## APPENDIX A DRB MARCH 11, 2019

Potrero Power Station Mixed-Use Redevelopment  
Responses to April 9, 2018 DRB Comments

**FIGURE 4-19-1** Outdoor Food Service Areas at Waterfront Park

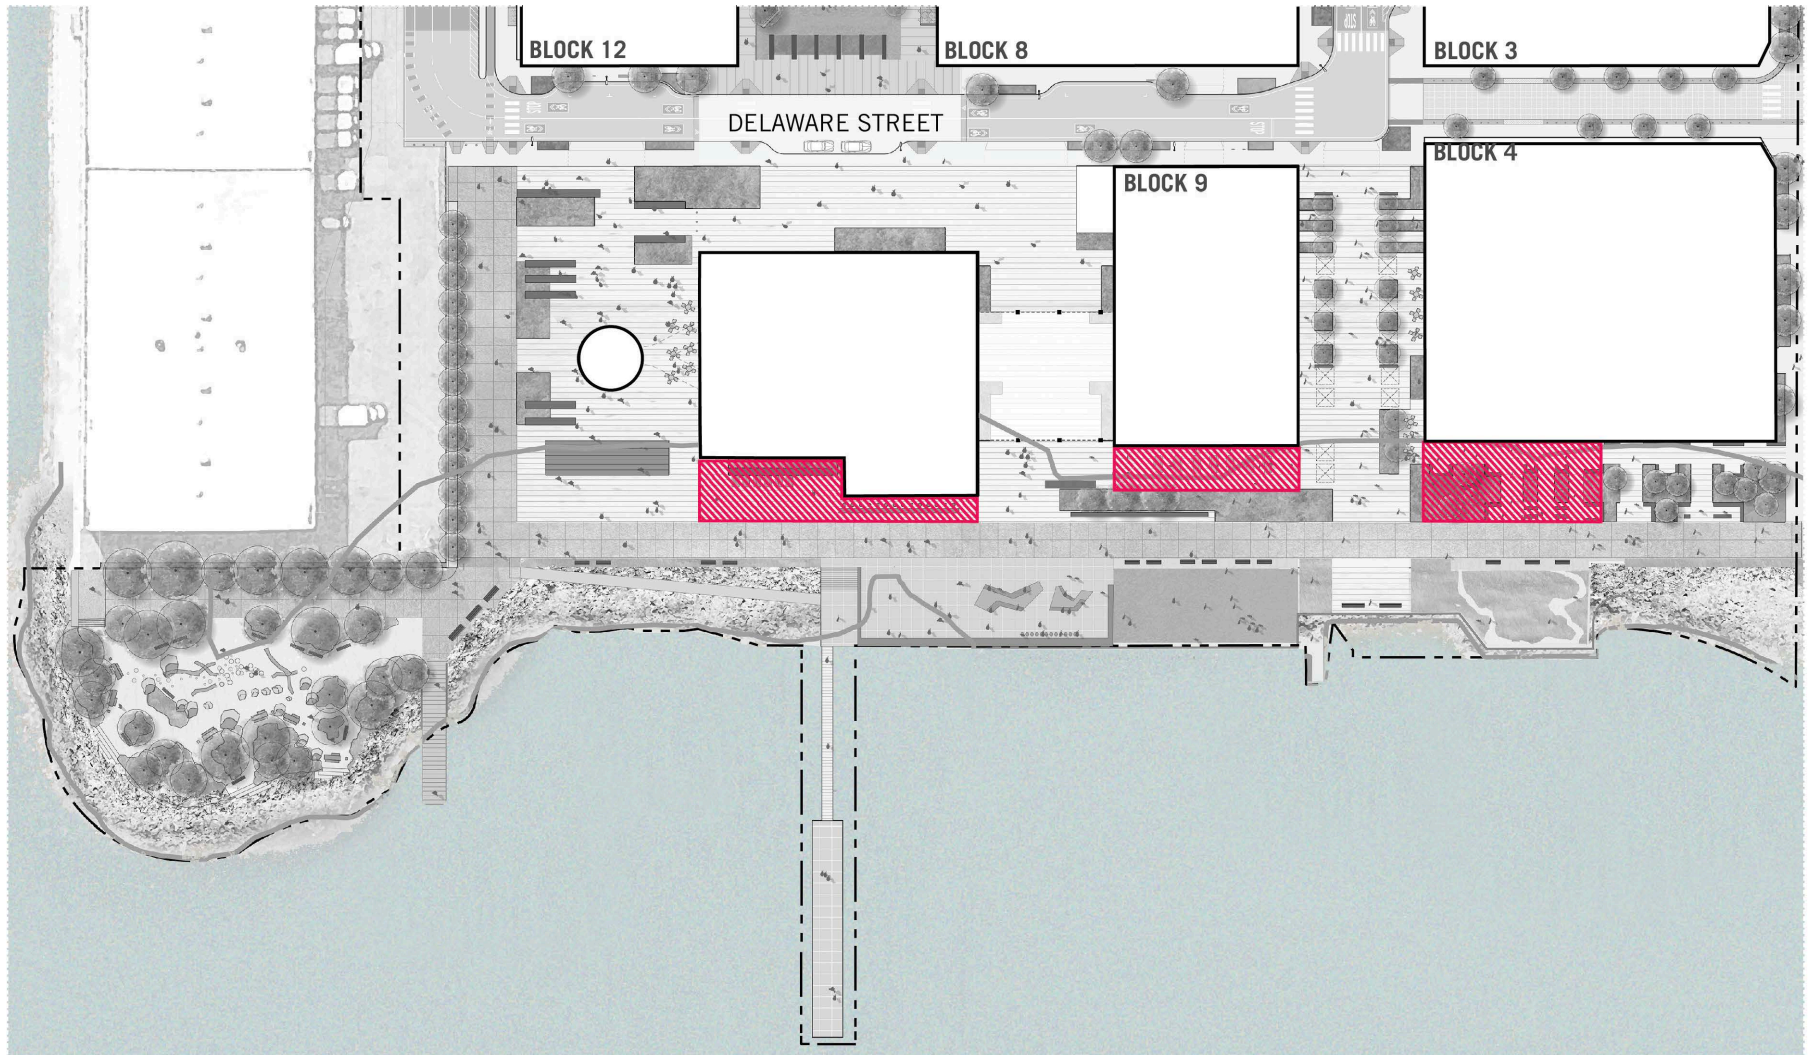
DRB SUMMARY AND CONCLUSIONS	
Physical and Visual Access:	Project Sponsor Response
(1) Ensure that the spaces adjacent to the buildings feel public.	We have carefully considered the publicness of spaces adjacent to buildings, and require that at least 40 percent of the seating areas adjacent to eating establishments remain open to the public, without a requirement for patronage of eating / drinking establishments. This is a requirement stated in our Design for Development document, as shown in the attached excerpt (Attachment 1).
